28 January 2025

**Factory, Manchester (Colonnaded Viaduct – Section 19)
Section 19 Application for Amendments to Listed Building Consent Ref: 128536/JO/2020**

“S19 application to vary conditions 2 (approved drawings) and 4 (arch finishes) attached to application ref no 128536/JO/2020 to reflect minor changes to the approved scheme including a revised approach to the grating details of Arch 1 of the Grade II listed Colonnaded Viaduct.”

Figure 1 Arch 1 North Elevation of Grade II Listed Colonnaded Viaduct (encircled in green)

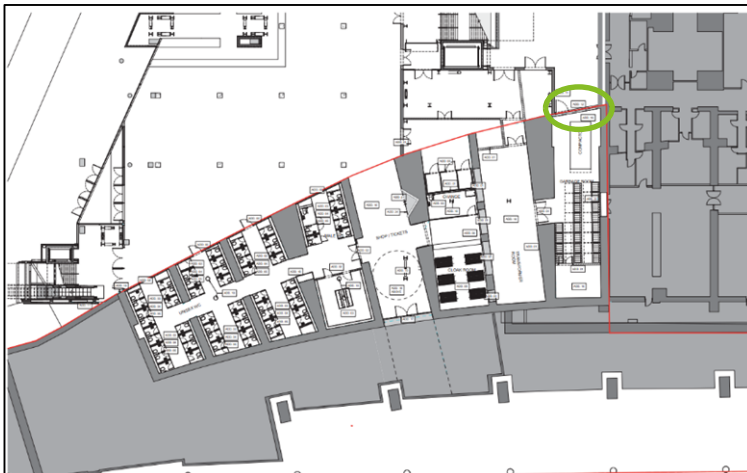
The Proposed Amendments relates to the grating treatment of Arch 1 North Elevation of the Grade II Listed Colonnaded Viaduct (indicated in Figure 1 below, encircled in green).

The approved position of Arch 1 of the Grade II Listed Colonnaded Viaduct, under the S19 Permission #2, would have seen the installation of a substantial grating treatment sitting in front of the Arch in its entirety and the brick façade of the Arch covered up.

Following detailed design development, the grating to Arch 1 of the Grade II Listed Colonnaded Viaduct has been amended to allow the grating treatment to set back into the Arch (instead of sitting in front of the Arch), following the shape of the Arch, therefore reducing extent of the grating treatment and allowing more brickworks on the façade of the Arch be exposed.

Figure 2 Arch 1 of the Grade II Listed Colonnaded Viaduct (Project team's own photo)

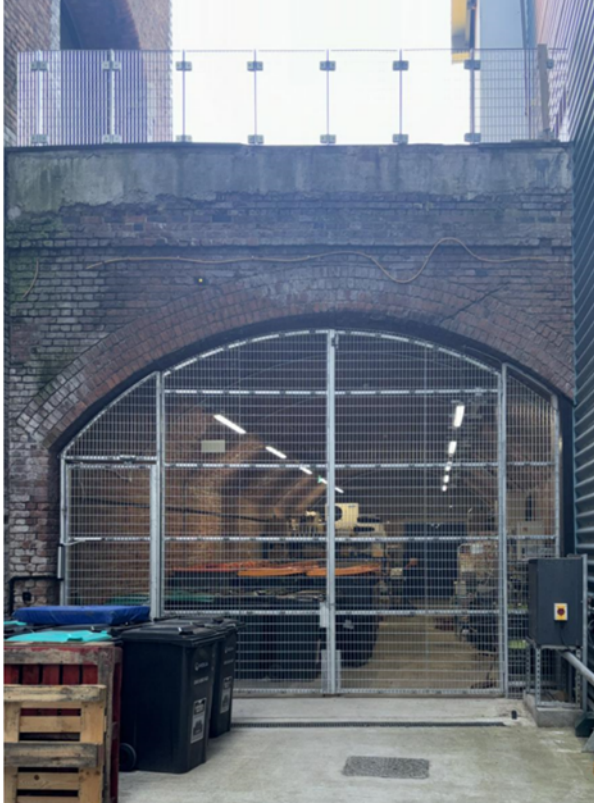
A photographic record of Arch 1, as seen on-site with Case Officer and Conservation Officer from Manchester City Council, is included in Appendix 1 of this Covering Letter.
